**Corrections to
THE LEADING EDGE, AERODYNAMIC DESIGN OF ULTRA-STREAMLINED LAND VEHICLES**

Goro Tamai
As of February 25, 2000
Thank you to the contributors.

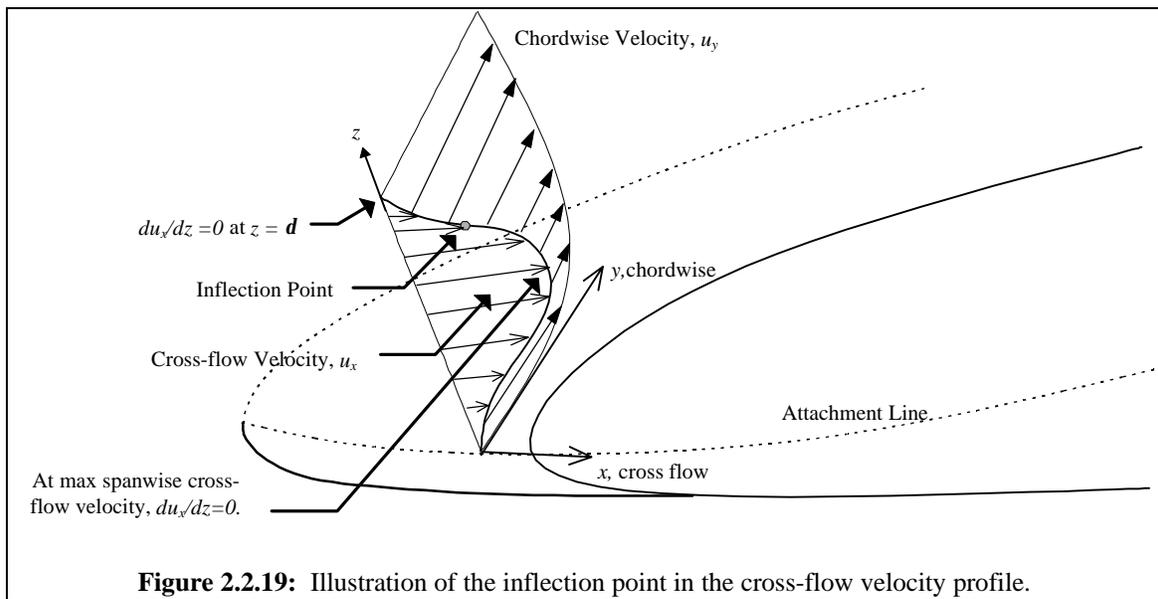
Page 29, Figure 2.2.2: Captions under figures have syntax missing.

Page 34, Figure 2.2.4 caption: "... Curve (c)'s laminar section follows Curve (a) up to 1.5 m."

Page 53, Figure 2.2.19:

The arrow from $du_x/dz=0$ at d should point to the upper edge of the boundary layer profile, the label "Chordwise Velocity u_x " should be "Chordwise Velocity, u_y ," and the label for the "Inflection Point" is missing.

Page 59, Figure 2.2.25:

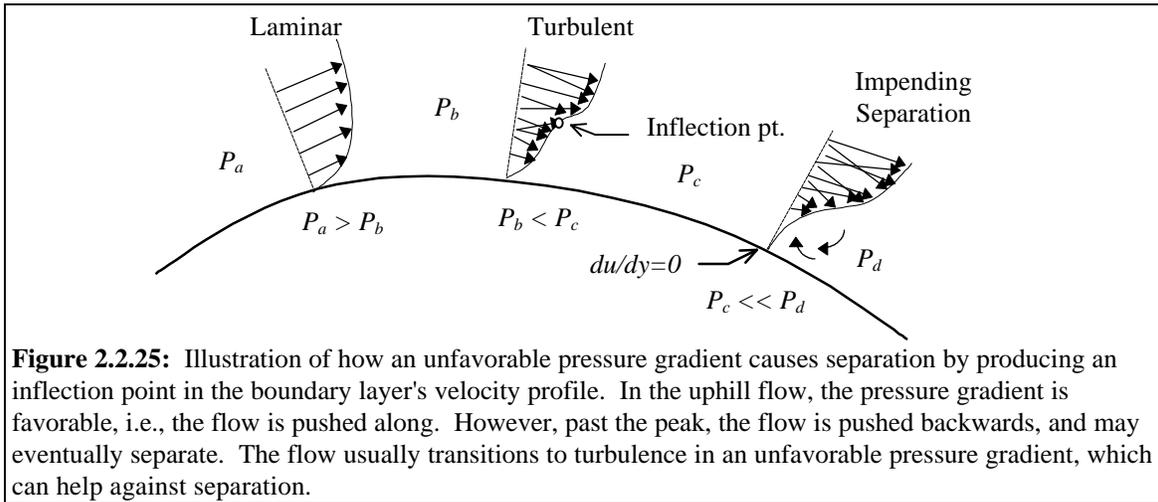
The inequality expressions below the boundary layer depictions should be as shown below.

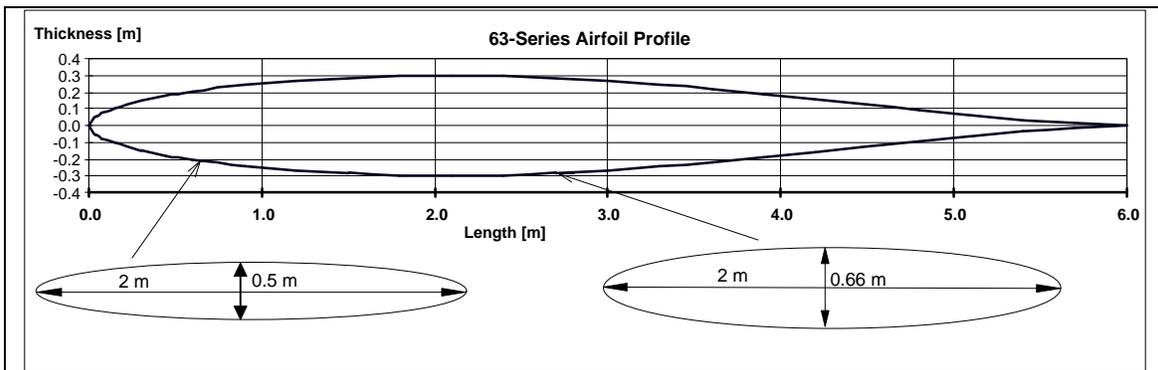
Page 92, Figure 3.2.21:
The dimensions of the ellipses are missing.

Figure 5.3.x: A 1/4-scale model of the 1995 MIT Manta was tested to find how sensitive the car was to changes in angle-of-attack. The model was hung upside-down. Milton D. Wong makes adjustments to the floor fixture.

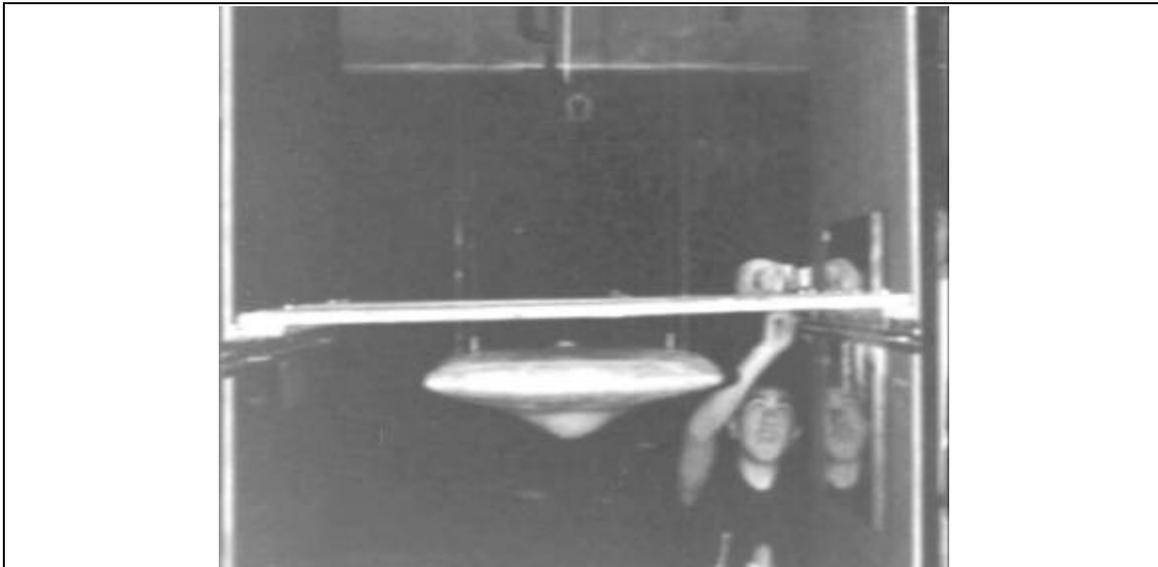
Page 125, first paragraph: “The MIT wind tunnel setup is shown in Section 5.3.1.” This photograph was edited out of the book due to poor resolution. The photo is shown below:

Page 208, Figure 4.6.7:

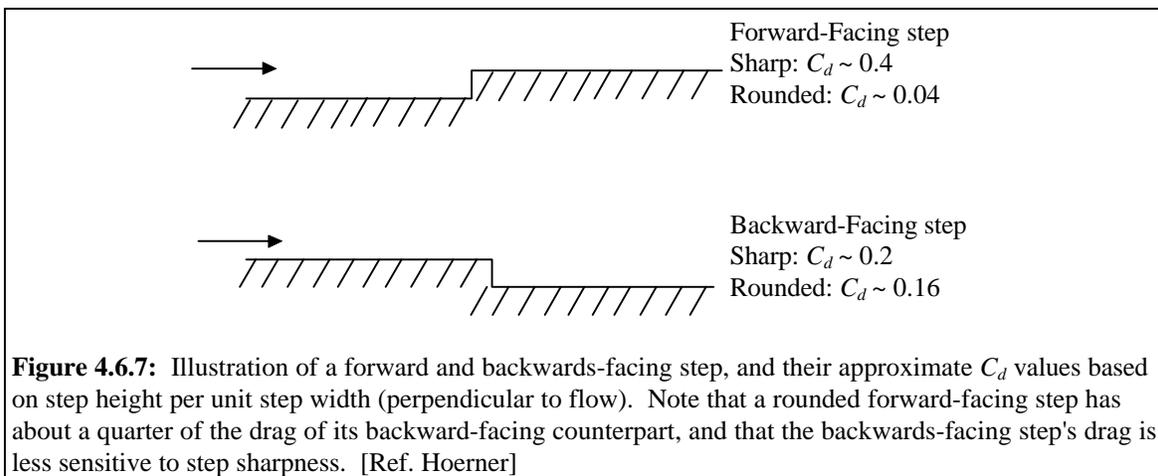
The caption should have read for the backwards facing step: Sharp ~ 0.2 , Rounded ~ 0.16 .
